AP1000 Press Conference Statement

Arnie Gundersen, Chief Engineer, Fairewinds Associates, Inc

AP1000
Chimney Effect
Draws
Radioactivity
Directly Into The
Environment

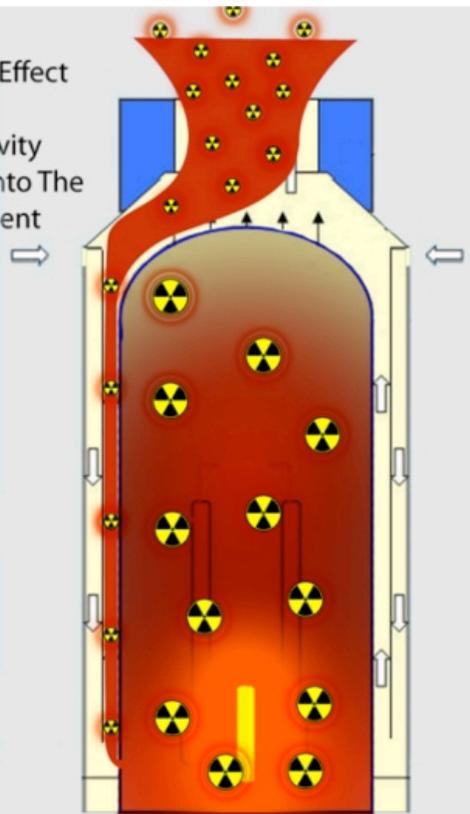
The AP1000 design is entirely different than previous reactor designs. Immediately outside the AP1000 steel containment is the so-called “shield building” that is as yet unapproved by the NRC. The AP1000 shield building does not collect radiation and trap it as in existing designs. Rather, the AP1000 shield building has a hole in its roof allowing radiation to escape. The AP1000 design uses a chimney effect to draw up contaminated air that leaks out of the steel containment and releases it directly into the environment through the hole in the roof. Radiation that leaks from the steel containment is neither captured nor filtered.

There is a solution to this problem but the NRC has not required Westinghouse to implement it. Implementing this solution would increase Westinghouse’s construction costs. To my knowledge, Westinghouse has not evaluated previous industry experience with holes in containments and assumes radiation breaching the containment is an extremely remote probability event. This is an erroneous conclusion given the fact that there have already been four holes in U.S. reactor containment systems. When Westinghouse applies these extraordinarily low likelihoods of failure, it attempts to show that the AP1000 does not need to filter post accident releases. My analysis and that of an

Italian nuclear engineering professor indicate that the AP1000 should be required to install filters in the roof-hole of its “shield building” in order to capture any gases that may leak out of the containment and through a rust hole similar to that at Beaver Valley. This step must be taken to protect public health and safety.

I also call on the NRC and ACRS to require that all AP1000 reactors install filters in the roof of the shield building in order to protect the public health and safety.
